MR #2024002 – BRINK ROAD BRIDGE OVER GREAT SENECA CREEK

Description

MR2024002
Prepared January 4, 2024

MCPB Item No 5
January 11, 2024

Figure 4: Proposed Bridge Cross Section

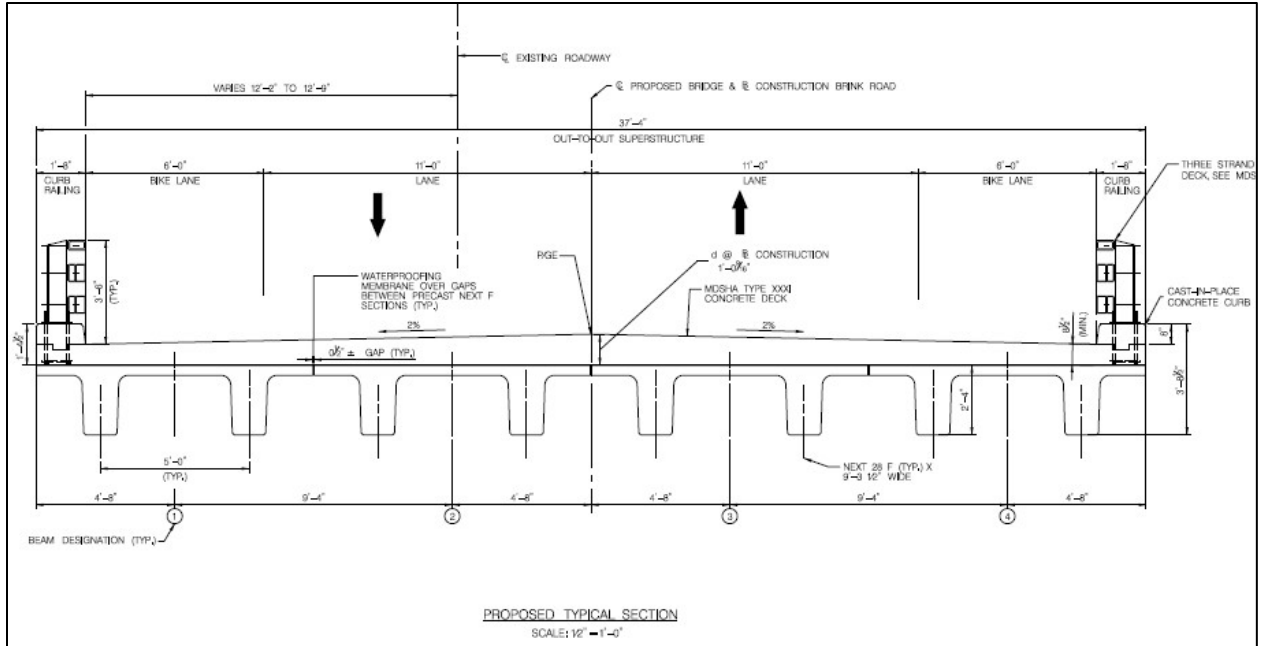
The proposed cross section is not fully consistent with the *Bicycle Master Plan*, as it does not include a sidepath on the south side of the bridge.

Recommendation: Widen the proposed bridge by eight feet for a total bridge width of 45 feet four inches (42 feet bridge clearance) in order to accommodate the master-planned sidepath:

- a 12-foot-wide sidepath on the south side, composed of a 1.5-foot-wide buffer from the bridge parapet, an 8-foot-wide sidepath, and a 2.5-foot-wide buffer with a protective railing,
- a two-foot-wide shoulder between the planned sidepath and the travel lanes,
- two 11-foot-wide travel lanes, and
- a six-foot-wide shoulder on the north side.
- The sidepath across this bridge should connect to the Seneca Greenway Trail on the east side of the bridge.

Figure 11: Proposed Detour Route During Construction

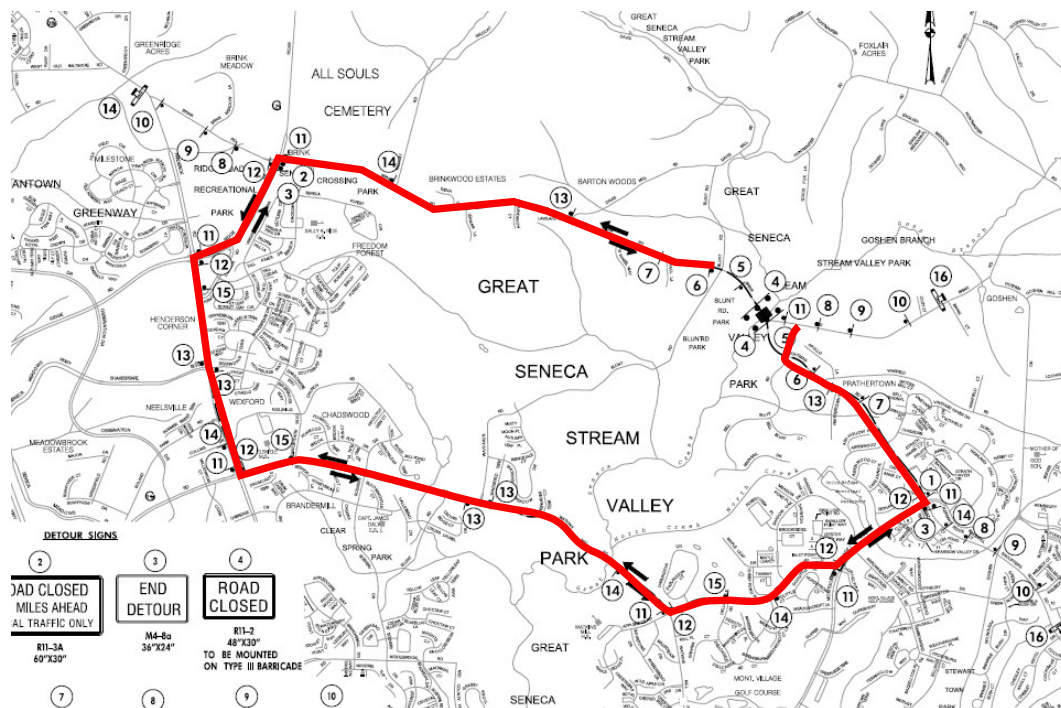
A traffic detour study was submitted by MCDOT evaluating existing peak hour traffic conditions. This study, however, appears to be incomplete in that it did not forecast likely traffic diversions, evaluate detour traffic operations on those roads, or propose detour mitigation. The traffic detour route and recommendations, shown below in Figure 11, appear sound and logical and should minimize the potential for any undue neighborhood traffic impacts.

Recommendation: MCDOT should complete a detour study as part of future design efforts to ensure that traffic impacts during construction will be minimal or mitigated by construction mitigation efforts.

Figure 14: Parkland to Be Converted to MCDOT Right-of-Way (Sheet 1 of 2)

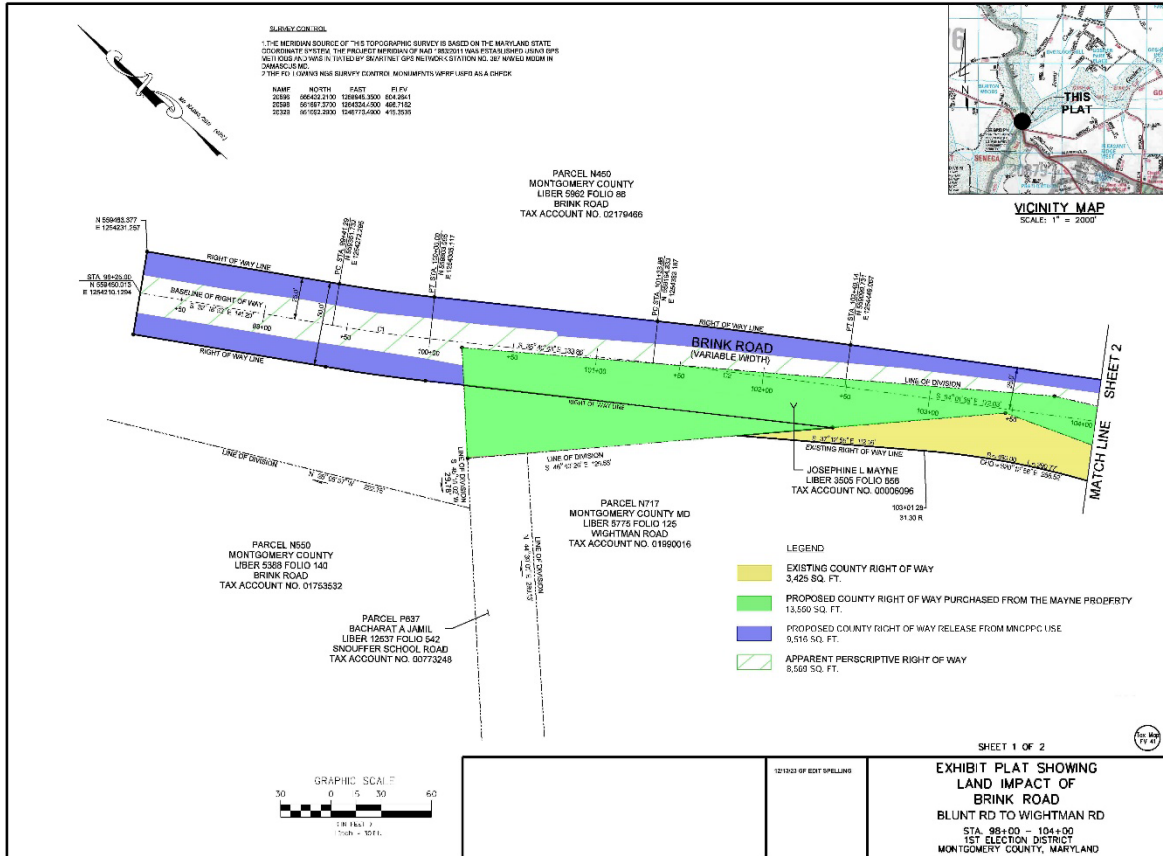
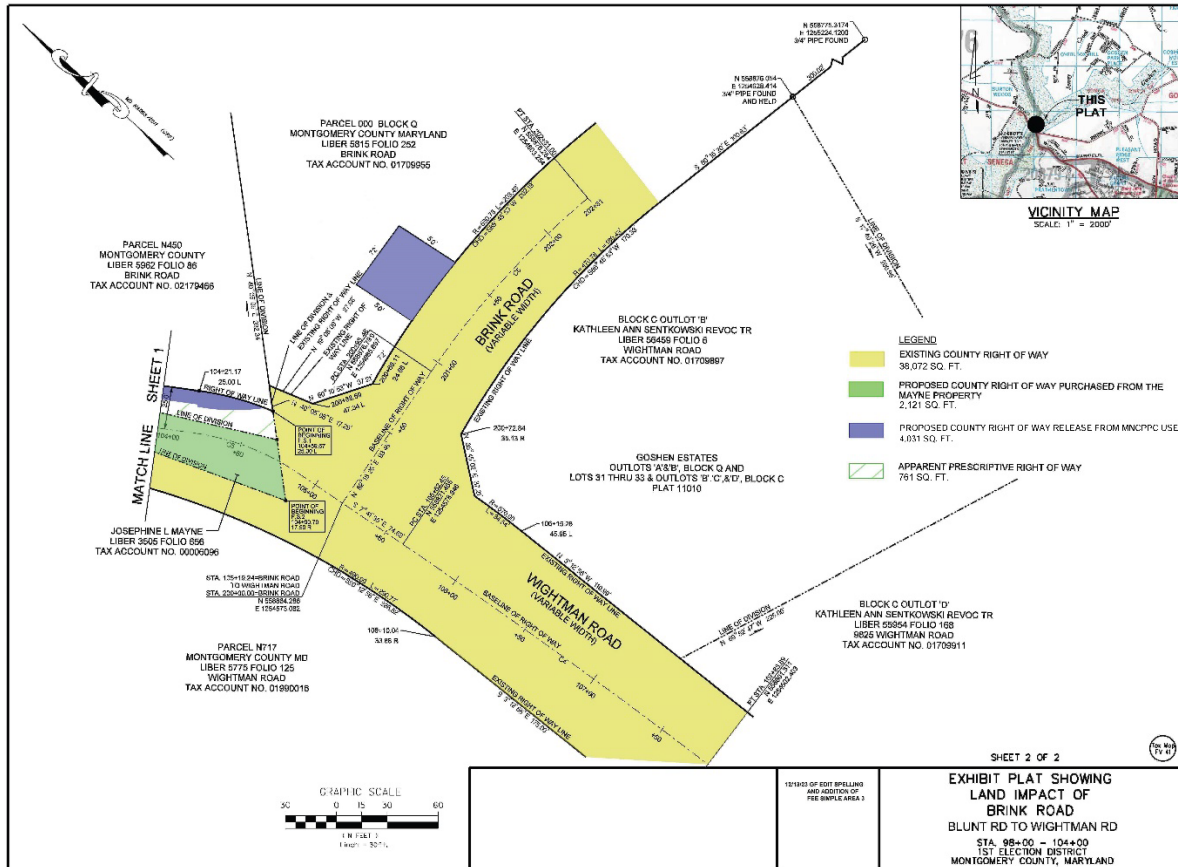
The current project plan indicates approximately 14,000 square feet (0.32 acres) of Great Seneca Stream Valley Park needs to be added to the MCDOT right-of-way to accommodate the new bridge structure and roadway improvements, creating a permanent impact to the park. Since this land is County-titled parkland under control and management of the Commission via the 1972 County-Commission Agreement, property rights will be transferred to right-of-way via a Release Agreement that the Commission will execute and place in the county land records. Since the funds used to acquire this land was appropriated to the Commission for parks and open space purposes, M-NCPPC must be compensated at fair market value for the land area that will no longer be serving park purposes. Payment for the new right-of-way area must be made to Montgomery Parks prior to issuance of the Park Construction Permit. Commission land that is proposed to be transferred to MCDOT is shown in purple in Figure and Figure .

Recommendation: MCDOT must compensate the M-NCPPC at fair market value for all land that will transfer from M-NCPPC’s Great Seneca Stream Valley Park to MCDOT’s road right-of-way, estimated at approximately 14,000 square feet. Payment for the transferred land must occur before issuance of the Park Construction Permit. The new right-of-way area will be transferred to MCDOT by M-NCPPC via a Release Agreement recorded in the County Land Records.

Figure 16: Proposed Replacement Parkland (Approximate) for POS Conversion Application to MD DNR

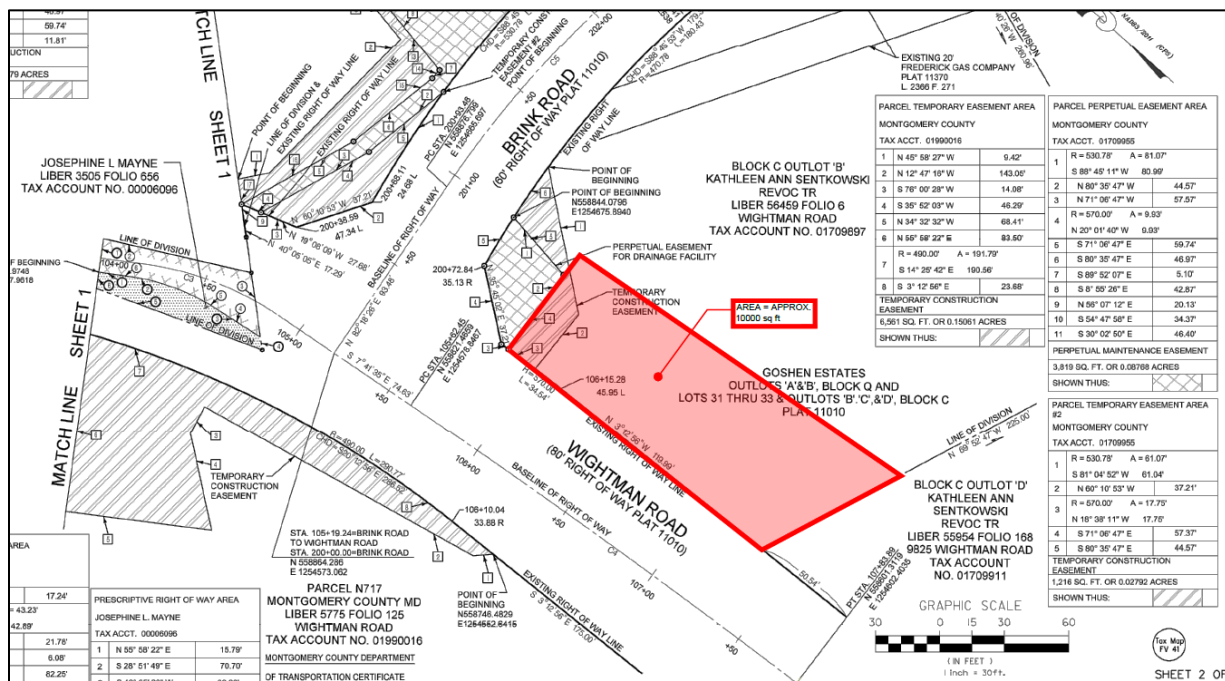
Approximately 9,870 square feet of the total parkland being transferred into MCDOT right-of-way was originally acquired with State Program Open Space (POS) funds that will result in a “conversion” of POS parkland that must be addressed. Maryland Department of Natural Resources (MD DNR, the agency that implements the POS program) requires that any POS purchased land converted away from public recreation and open space be replaced with new parkland that is of equal or greater land area, appraised land value, and recreational value.

To satisfy these POS conversion requirements, MCDOT proposes to purchase part of the Sentowski property at the corner of Brink Road and Wightman Road and transfer ownership to M-NCPPC (see Figure). This replacement land will be approximately 10,000 square feet to meet the land area

Recommendation: MCDOT must provide an appropriate parcel of new parkland as a replacement for the State Program Open Space (POS) funded parkland this project will convert to right-of-way, approximately 9,870 square feet, prior to the issuance of a Park Construction Permit.
